I object to the whole of the WestConnex Project, and the specific WestConnex M4-M5 Link proposals as contained in the EIS application, for the following reasons:

I submit this objection to the WestConnex M4-M5 Link proposals as contained in the EIS application # SSI 7485, for the following reasons, **and ask that the Minister reject the application.**

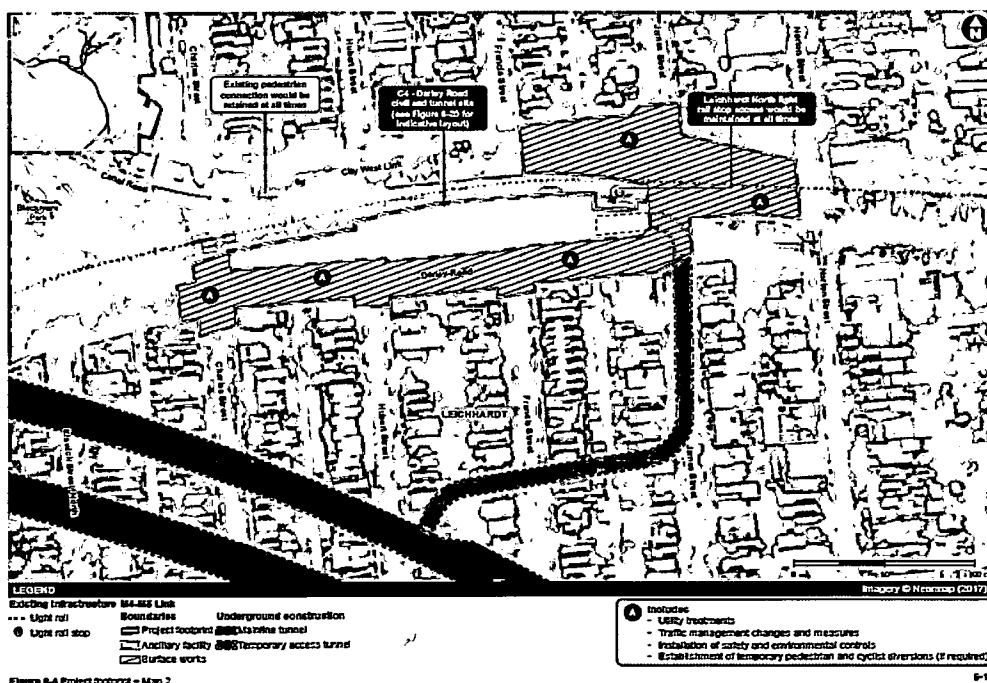
The EIS states in 6.5.8 Darley Road civil and tunnel site (C4) that:

'Temporary changes to Darley Road to enable access to and from the ancillary facility would likely be required. These may include changes to line marking to provide a temporary turning lane for construction traffic and temporary diversions to the pedestrian path on the northern side of Darley Road. These would be confirmed during detailed design following the appointment of a design and construction contractor and in consideration of the safety and function of the road network, maintaining access to the Leichhardt North light rail stop and providing for continued pedestrian and cyclist movement.'

It is not clear how continued access, pedestrian and cyclist movement will be preserved and I am concerned that the impacts have not been correctly identified and

assessed by the proponent.

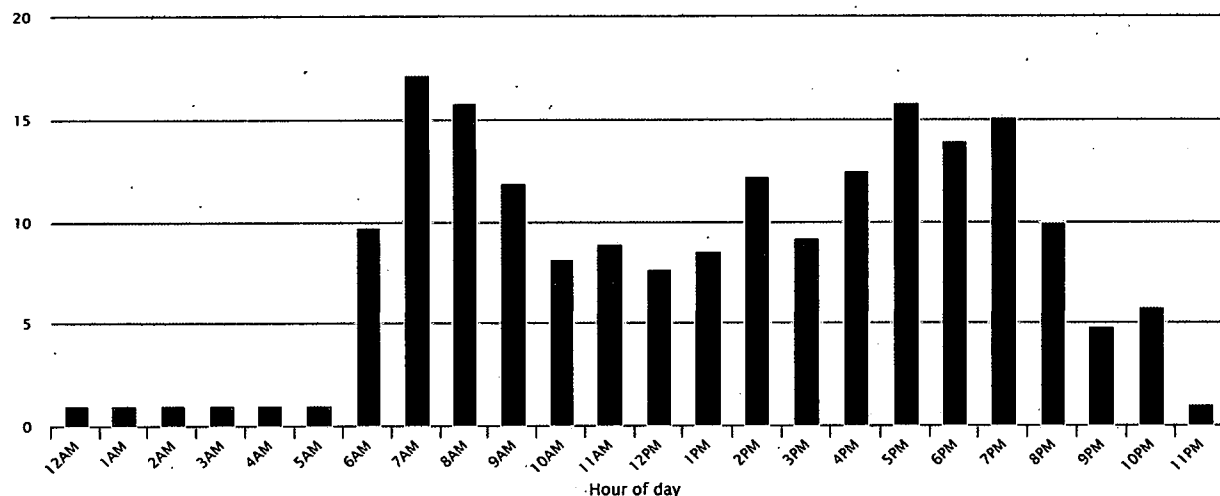
- I object to the EIS because the proponent has failed to take account of the cumulative impact of its proposed Darley Road, Leichhardt civil and tunnel site operations and the aircraft noise which the residents near the site already endure.

The attached extract from Webtrak shows that Darley Road, Leichhardt and adjacent streets are directly under the flight path.

Airservices Australia reports that in April to June 2017 the number of average daily noise events over 70 dBA. In Leichhardt this is an average of 16- 17 per hour over the peak morning period and 16 per hour in the early evening peak period.
